Date: December 14, 2017
To: Steven Ehlbeck,
SERA ARCHITECTS
From: Puja Bhutani, Historic Resource Review
Re: 17-202058 DA – Tuck Lung Project
Design Advice Request Summary Memo, October 9, 2017

This memo summarizes **Landmarks Commission** design direction provided October 9, 2017.

WEST ELEVATION (3/32" = 1'-0")

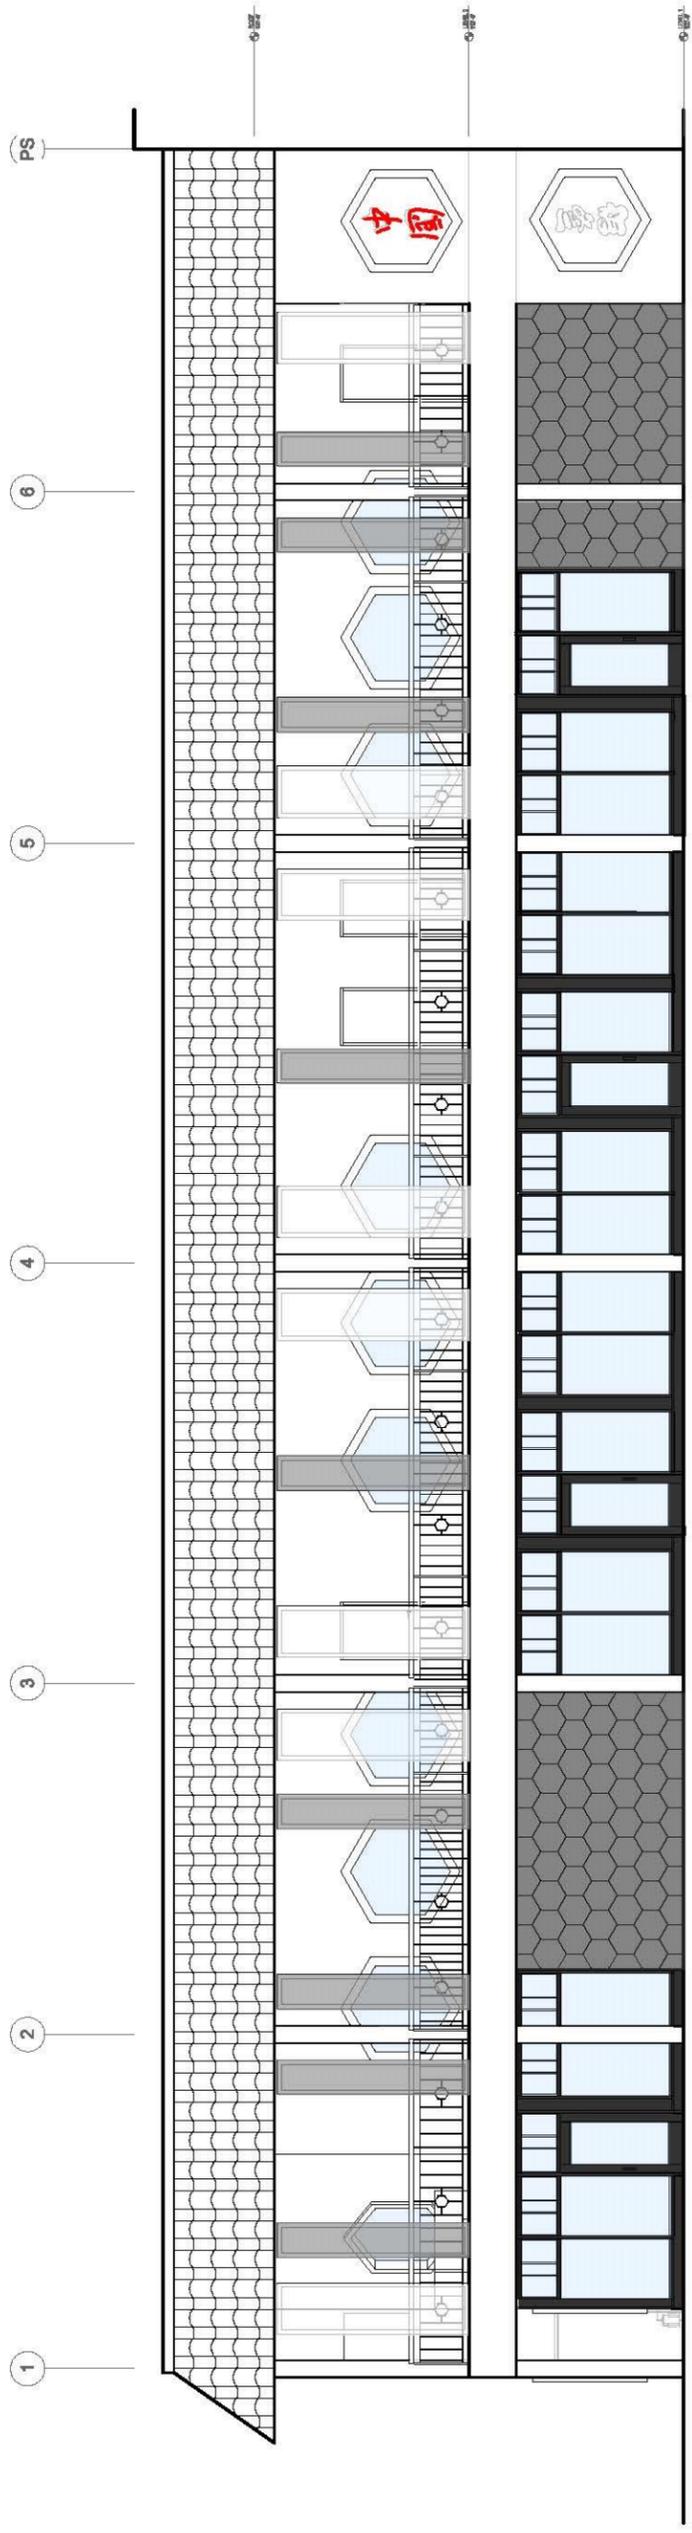
- **Storefront System.**
 - The upper and lower floors are not harmonious. Simplify the storefront system to create unity.
 - The corner was a place of symmetry and the 3 pane storefront pattern should be carried around the corner to the north elevation.

- Vertical window partitions seem too wide and not proportional to the storefront window. More layering was needed to break down the thickness of the vertical mullions.

- Transom seems overly busy. The proposed storefront transom hexagons are too small and not authentic. A reference to Chinese architecture would be more successful.

- **Entrances**
 - The corner was an important feature that should be recognized.
 - A corner entry would speak to what was there, and should be retained especially if the corner setback on the floor above remains.
